**ADDENDUM NO. 2**

PROJECT TITLE:  
**REPLACEMENT OF  
 BRIDGE NO. 06896, ROUTE 156  
 OVER ARMSTRONG BROOK**

TOWN:  
**OLD LYME**  
 DRAWING TITLE:  
**RIGHT-OF-WAY  
 PLAN**

PROJECT NO.  
**104-175**  
 DRAWING NO.  
**ROW-1**  
 SHEET NO.  
**03.02.A2**

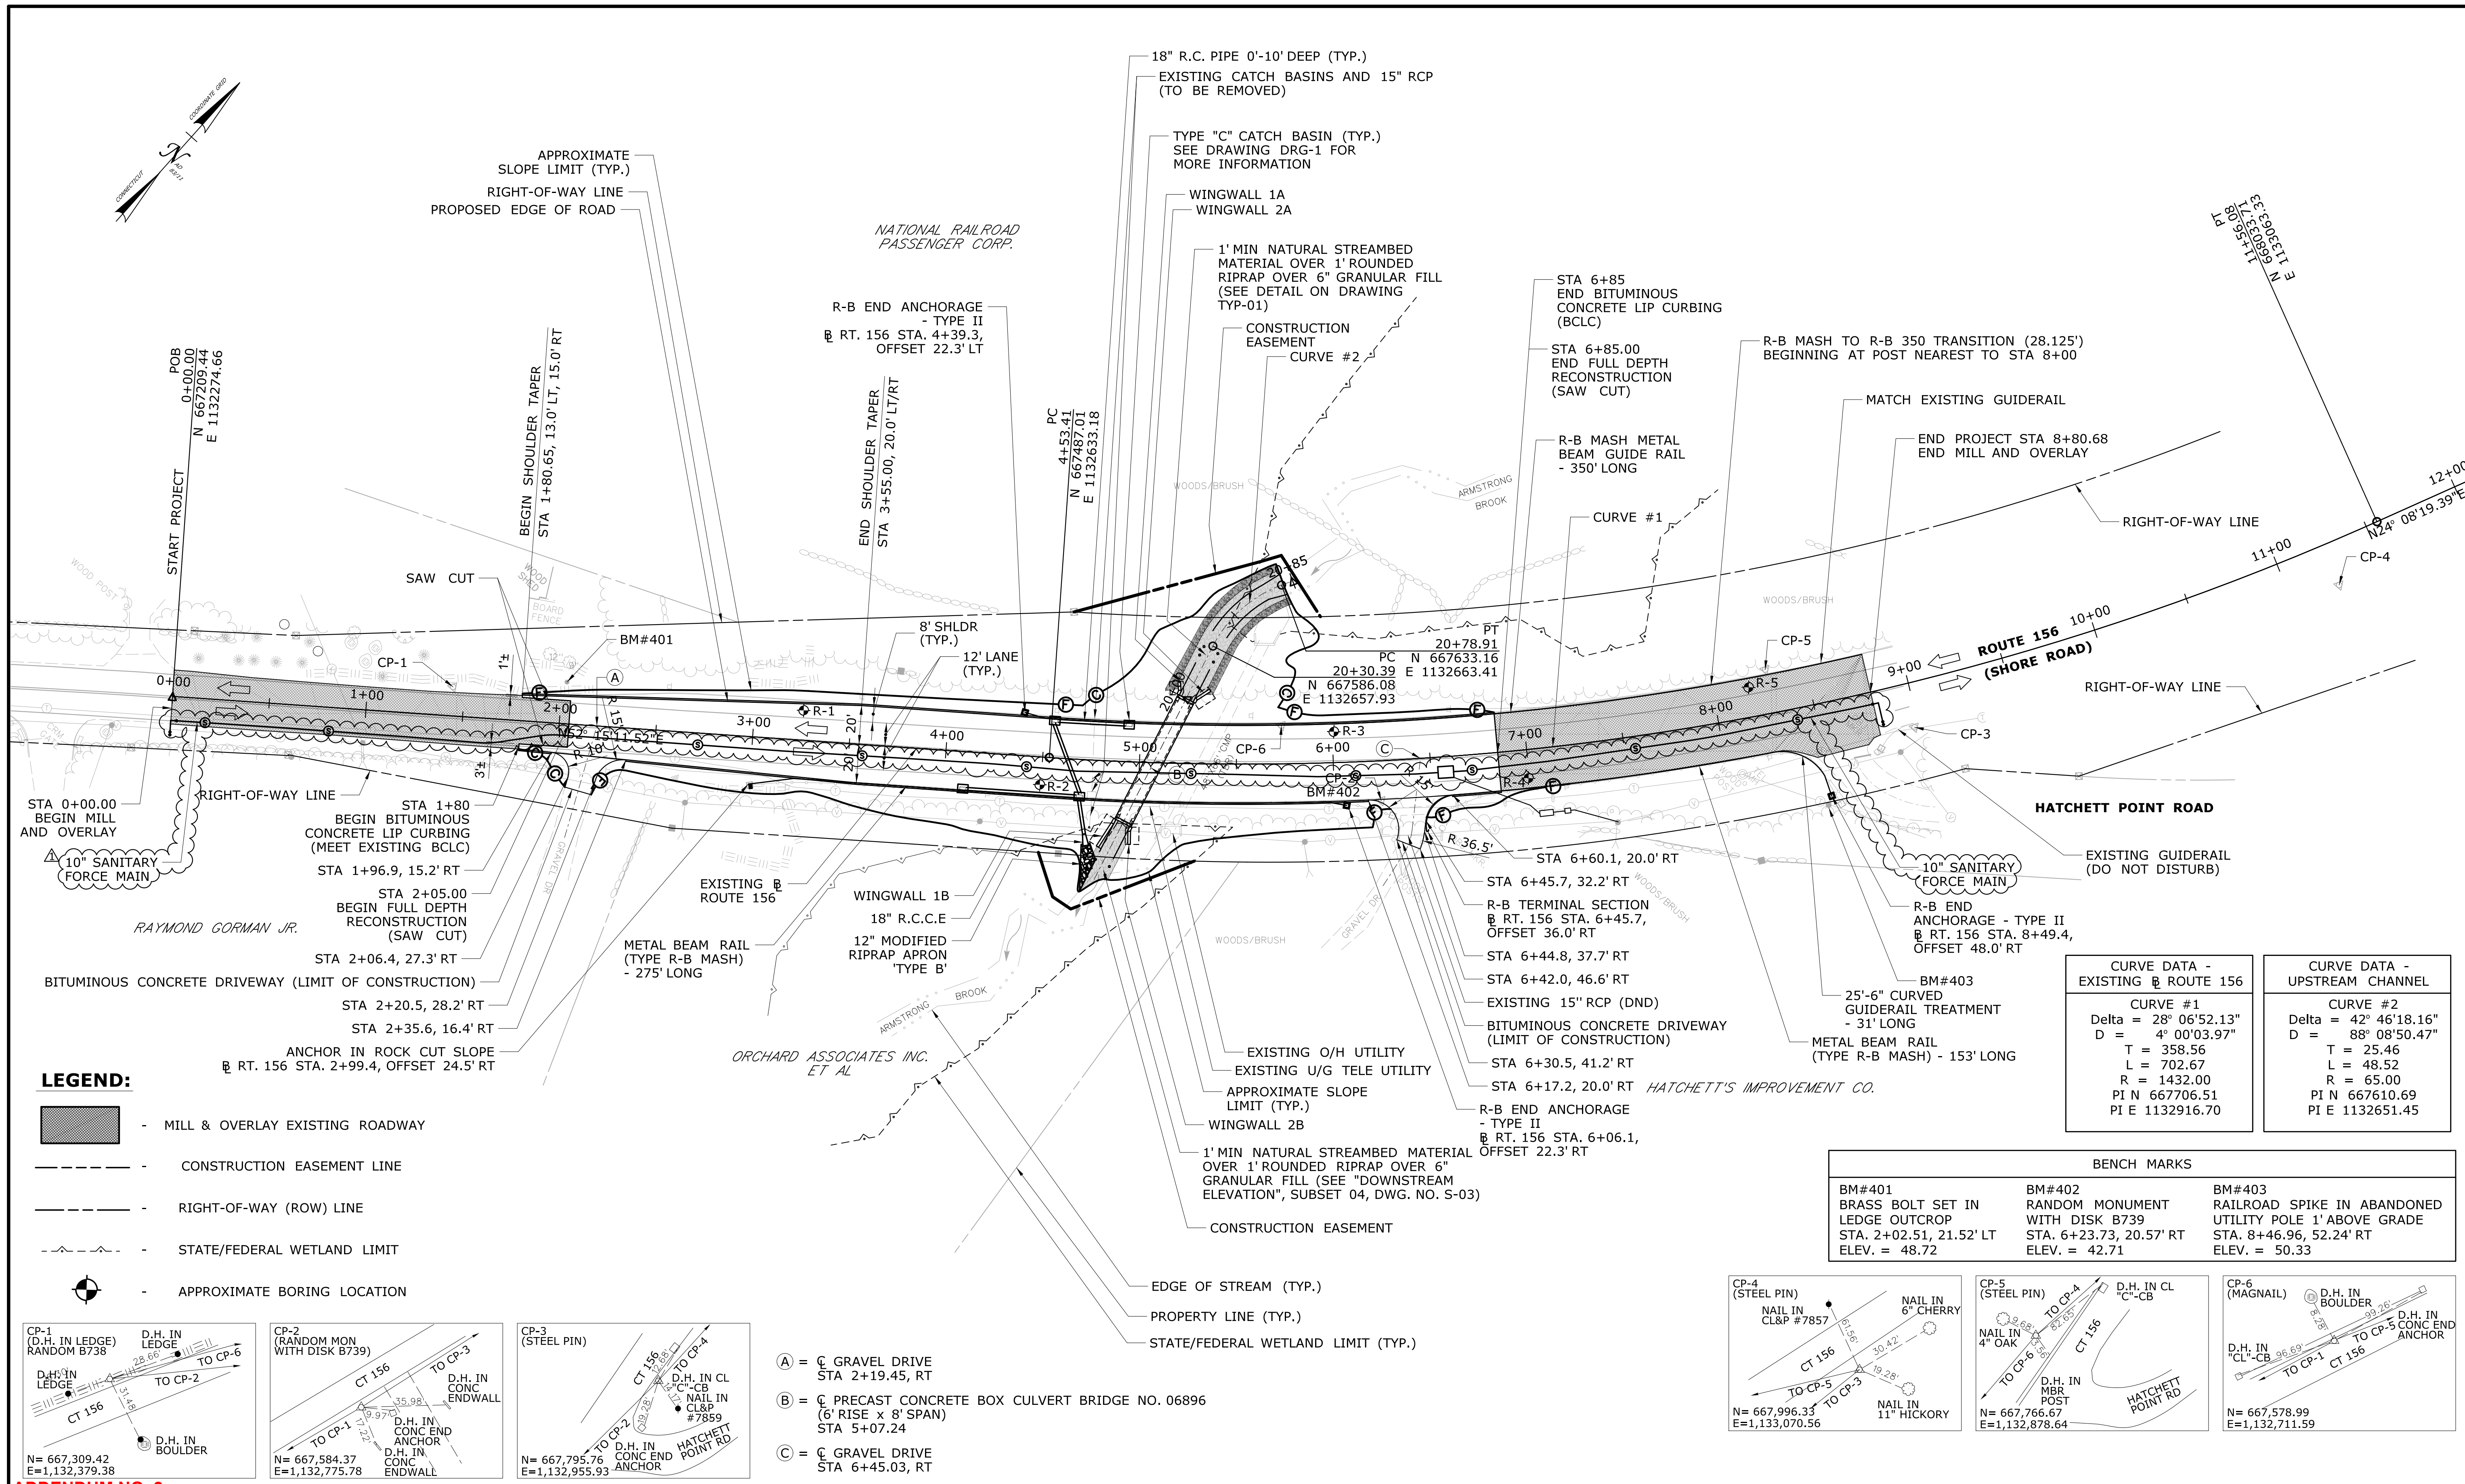
REV.	DATE	REVISION DESCRIPTION	SHEET NO.
1	01.31.25	ADD SANITARY FORCE MAIN	03.02
